Accessibility Survey

Transportation Depot Center

8150 Nance Avenue
Downey, CA 90240

Date of Inspection
10/22/2016

Door , Hardware : Door Opening Pressure

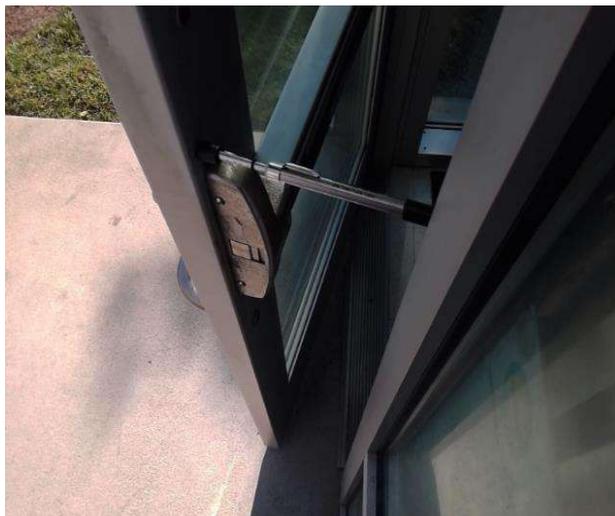
The door opening force for this door is greater than allowed.

On-Site Finding 15.00 pounds

Adjust the closer on the door to meet the door opening force requirements.

Recommendation Up to 5.00 pounds

Door , Hardware : Door Opening Pressure

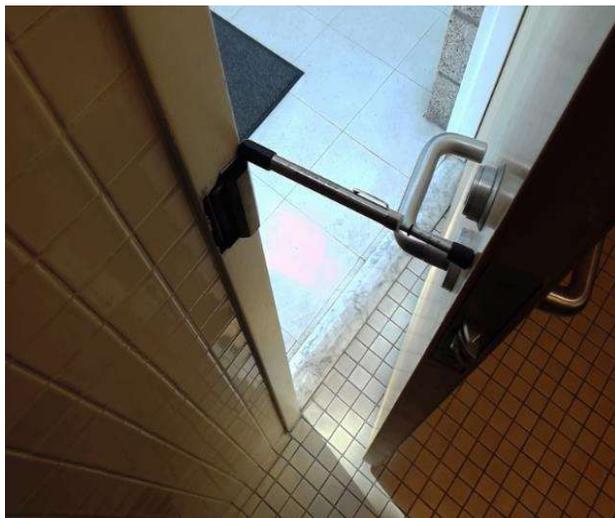
The door opening force for this door is greater than allowed.

On-Site Finding 12.00 pounds

Adjust the closer on the door to meet the door opening force requirements.

Recommendation Up to 5.00 pounds

Door , Clear Floor Space : Floor Mat

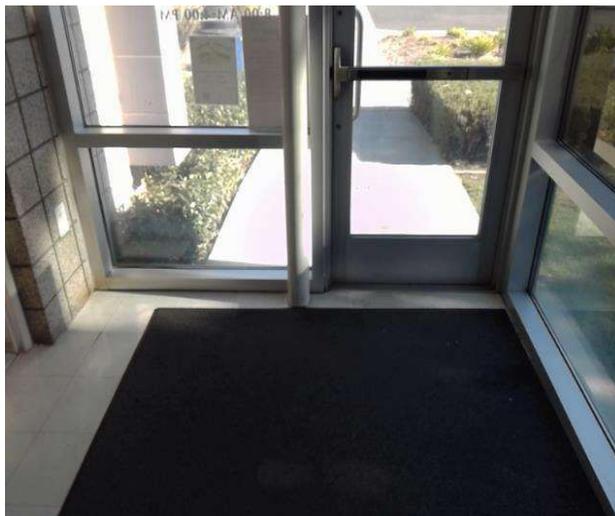
An unstable floor mat is provided at the door landing.

On-Site Finding Not Compliant

Notes : Pole obstructs latch side clearance.

Provide a compliant floor mat for the door.

Reach Range , Element Highest Point of Operation : Element Highest Point of Operation

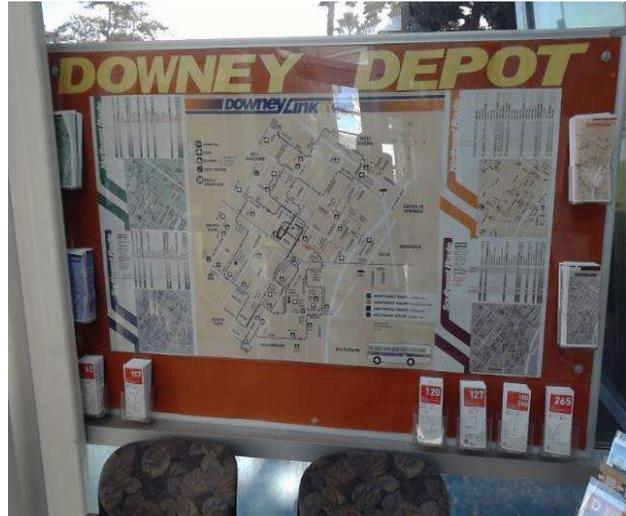
The highest point of operation for the element is not compliant.

On-Site Finding 65.00 inches

Make sure that the highest point of operation is within the recommended value.

Recommendation 15.00 - 48.00 inches
